## **CONSTRUCTION SUMMARY**

## Lindsay 2017 Developments Inc. / Sugarwood

Lot/Unit: 36 Phase/Building: 2 Model/Floor Plan: Cavendish Lake (4210) Elev B 4Bed 4.5Bath

DocuSign Envelope ID: A8DFDB11-4986-4DAC-8AD8-A4C4965132F6
SCHEDULE "B-1"
Floor Plan

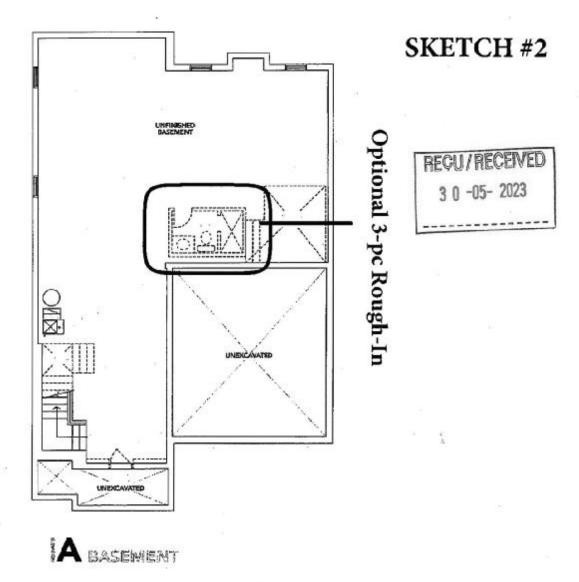
1 - TO SUPPLY AND INSTALL THE OPTIONAL SIDE DOOR.. SEE SKETCH #1
